Re:	Third Submission Review:	1900 S Chambers Community Lot 1 - Site Plan Amendment
	Application Number:	DA-2105-01
	Case Numbers:	2018-6020-03

Third Submission Review

1900 SOUTH CHAMBERS COMMUNITY LOT 1 SITE PLAN

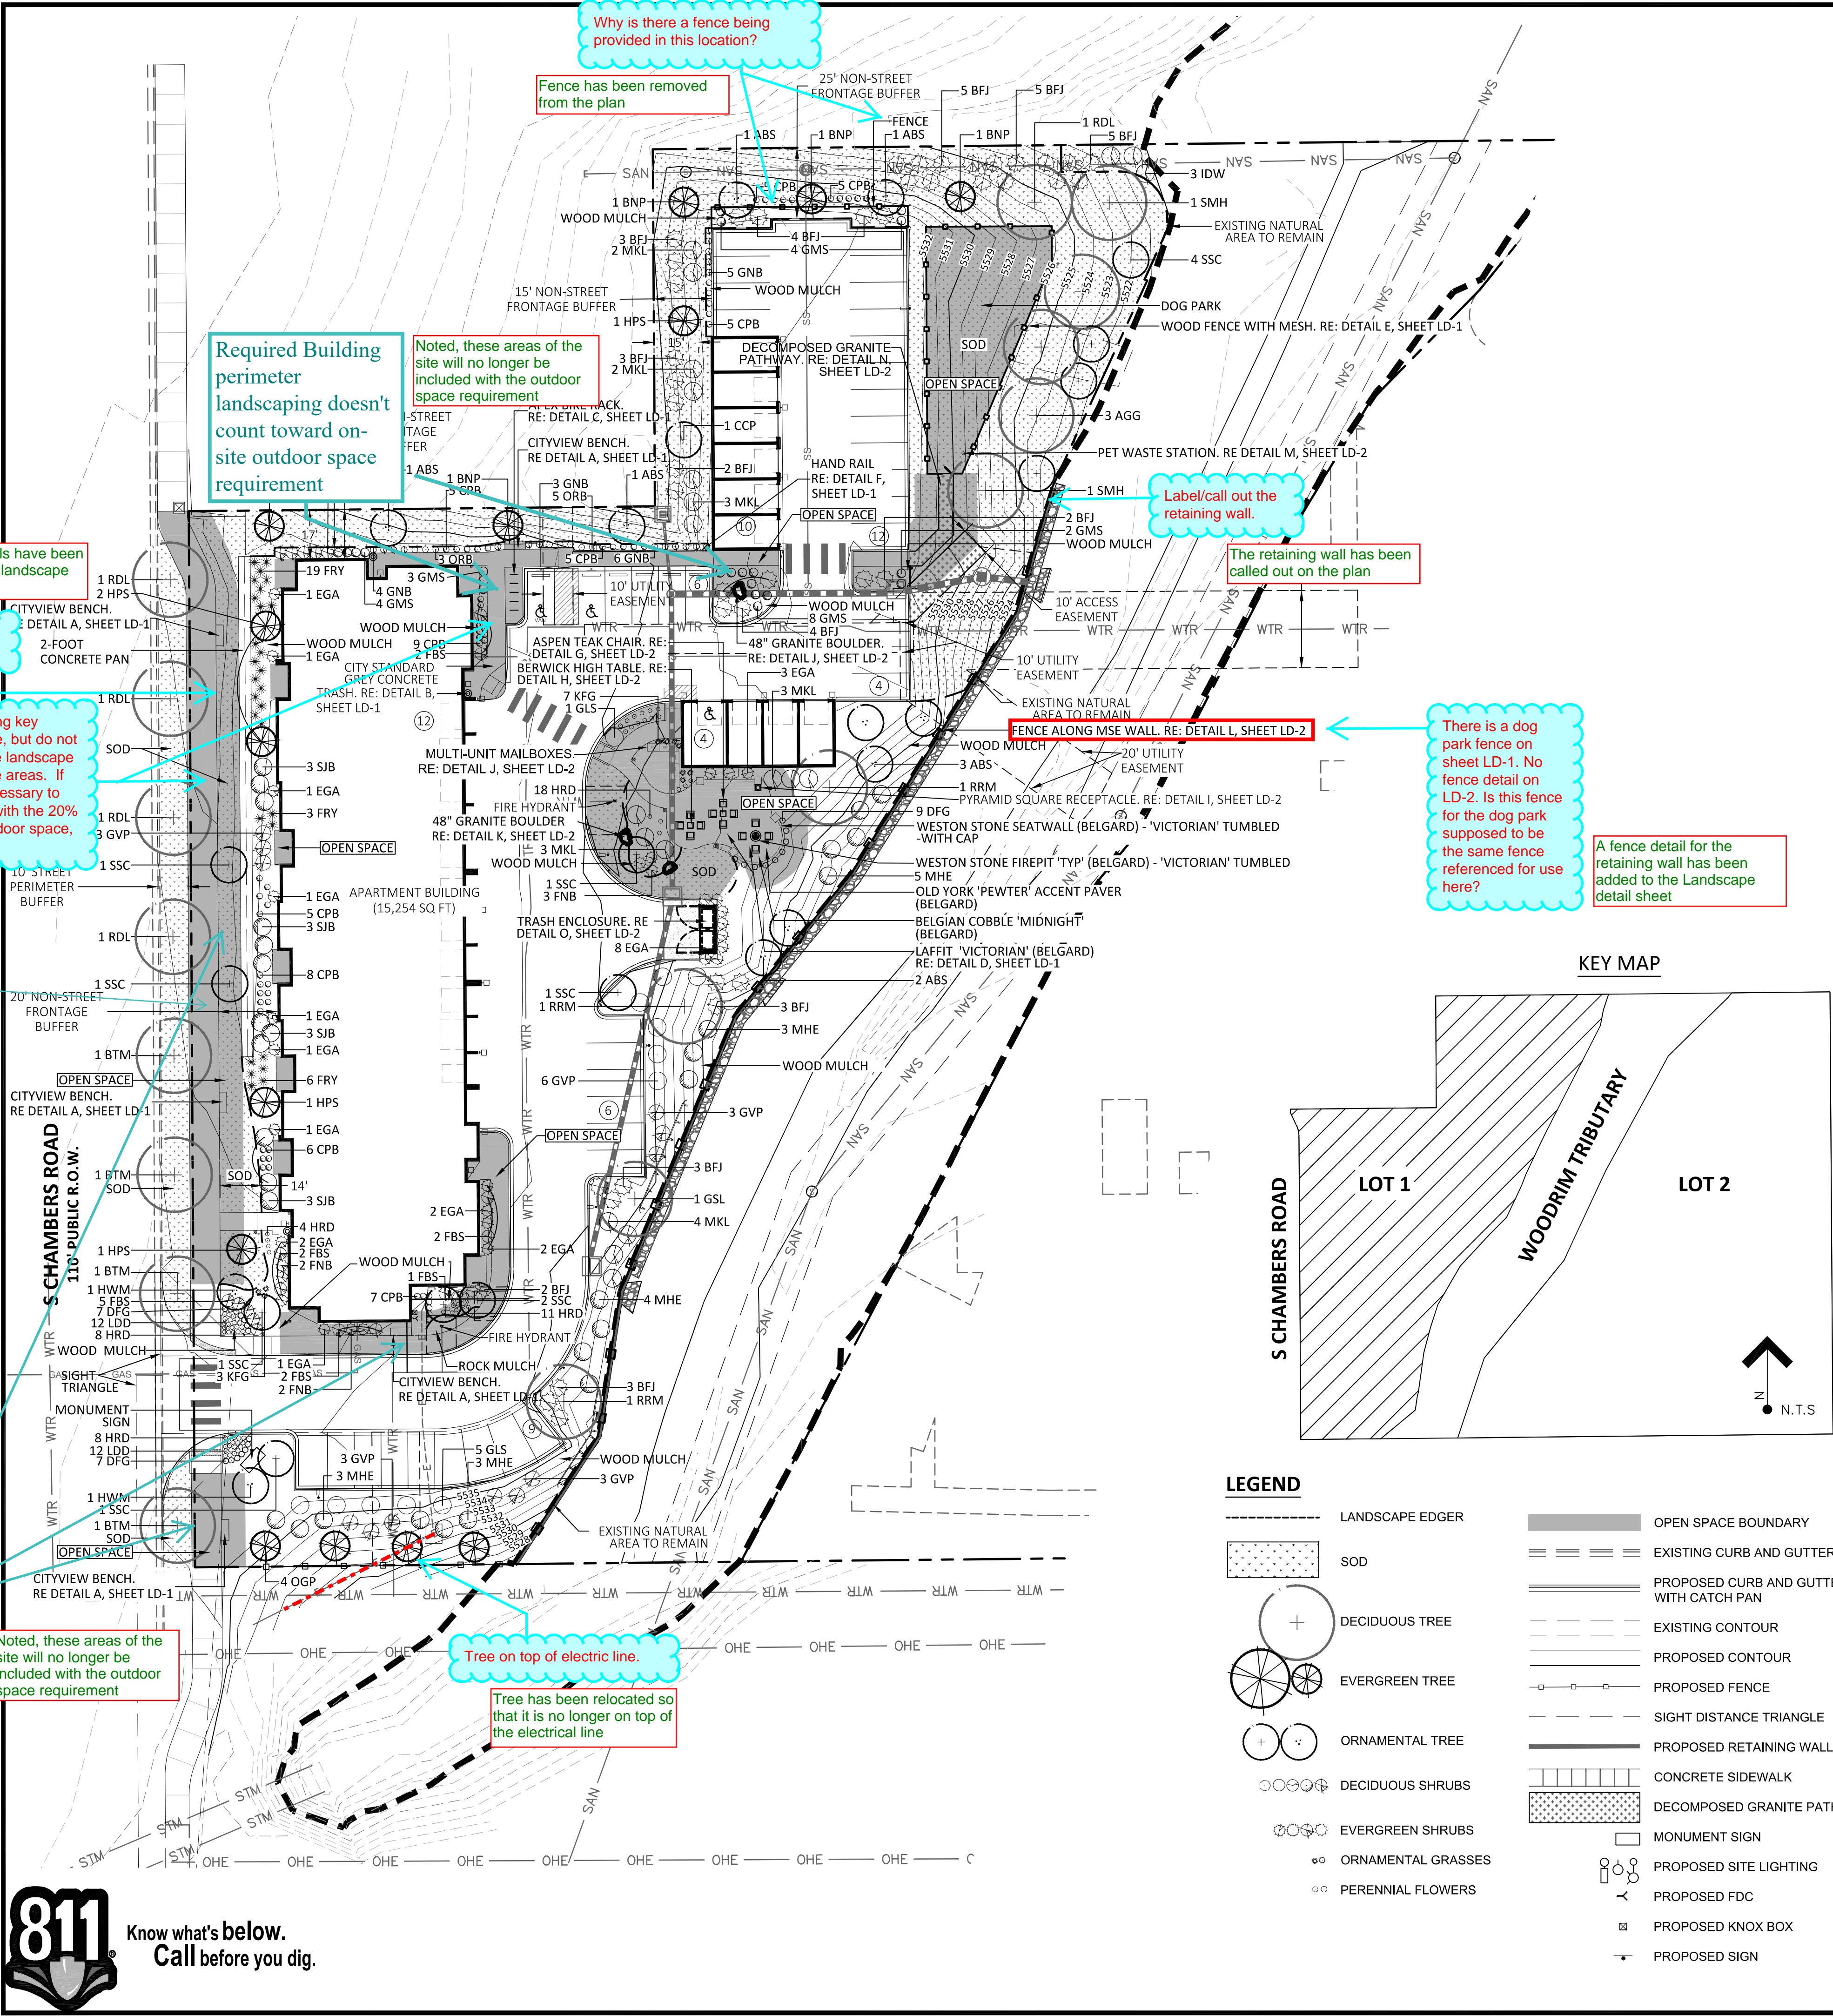
A. There appears to be a difference in the type of walls being proposed, but there has only been one detail provided for an MSE wall. Please include the detail with material/height/color etc. for the concrete wall as well.

- C. Please show the section across the floodplain with the elevation similar to the previously approved site plan.

- Response: A concrete wall detail has been added for the pour in place wall and the concrete patio seat wall. Both materials have been called-out with color, height, and material

- **Response:** Added cross section of the floodplain to the grading plan.

LD-2 (7 OF 11)

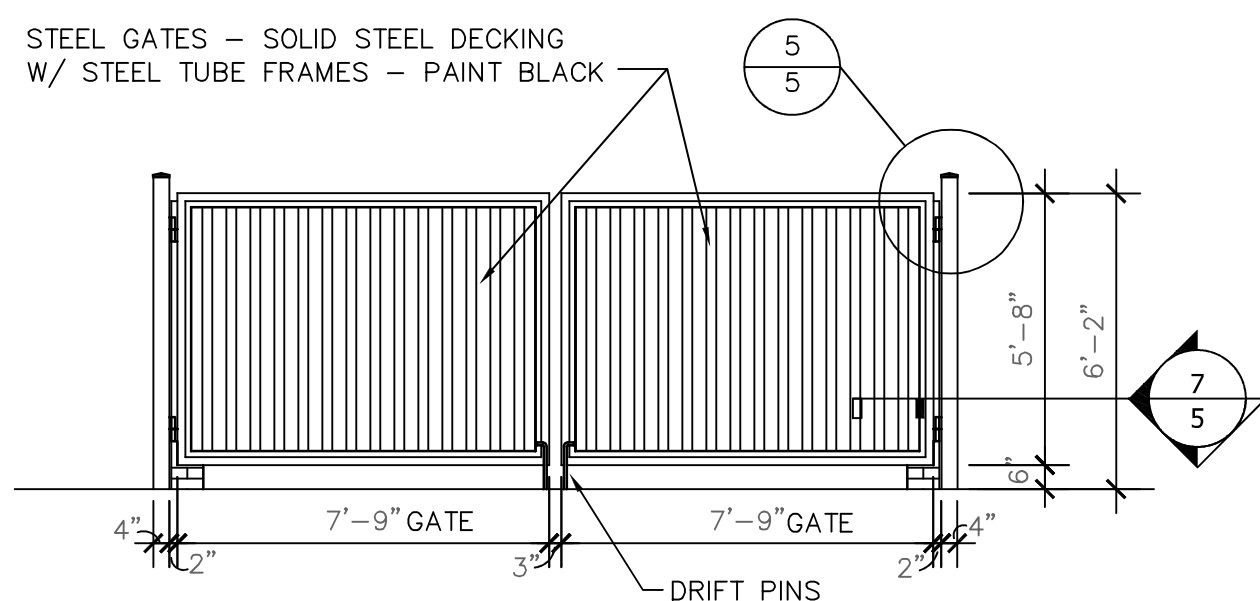
There appear to be two types of walls being proposed for this project. An MSE wall and what appears to be a concrete poured in place wall. Please provide a detail confirming material, height, color etc. for the non-MSE wall.

A concrete wall detail has been added for the pour in place wall and the concrete patio seat wall. Both materials have been called-out with color, height, and material

SHEET 8 OF 11

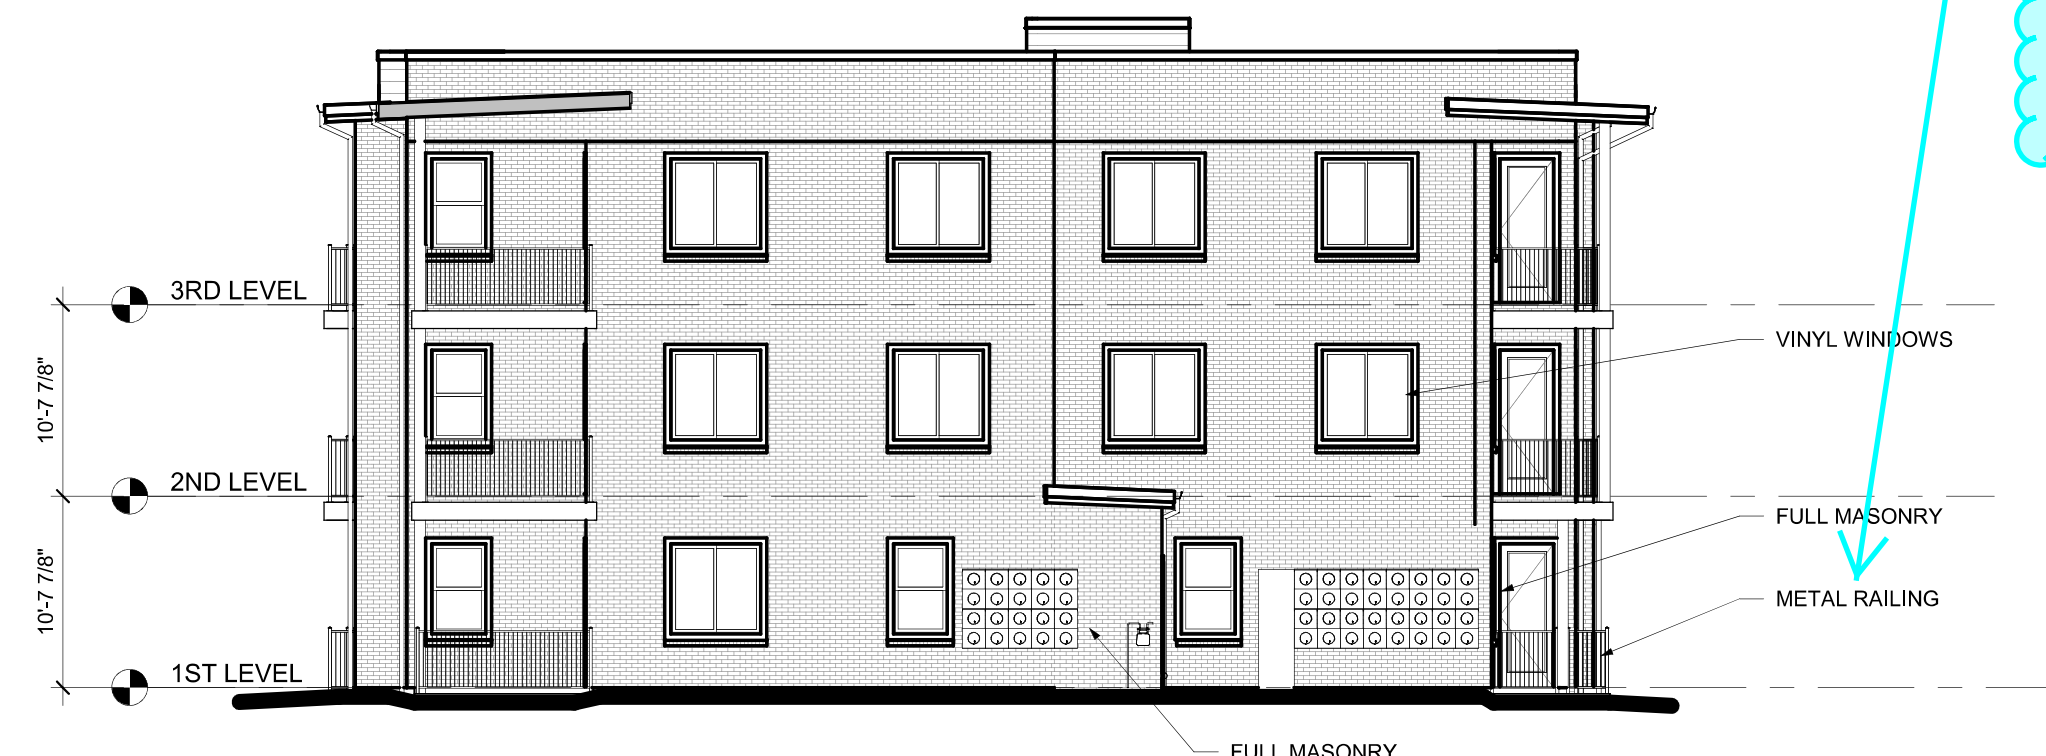
These elevations indicate railing is being provided, however the Site Plan labels these as walls. Will there be railing on top of walls?

THIS SHEET IS CORRECT. THERE IS RAILING ALONG ALL PATIOS. THE SITE PLAN NOW CALLS OUT THIS RAILING AS WELL. IN THE CASES WHERE A SMALL WALL IS PROPOSED ALONG THE PATIO'S PERIMETER, THE RAILING WILL BE INSTALLED ON TOP OF THE WALL.
